Advanced Technical Information

Bulletin #: 2014.2

AC Charging Hardware and Cable Temperature

Figure 1

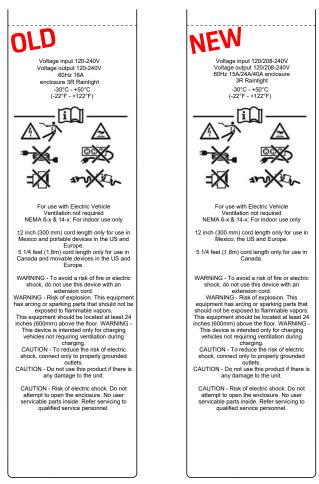
Errors exist in the label affixed to supply cables provided with vehicles produced before August, 2020, as well as cables currently available via normal parts channels.

Only one label variant exists and is affixed to all supply cables in USA and Canada (NEMA5-15, 6-/14-30, and 6-/14-50). Figure 1 shows the existing label with errors. Figure 2 shows the updated label.

The necessary recourse for labels with errors is being evaluated.
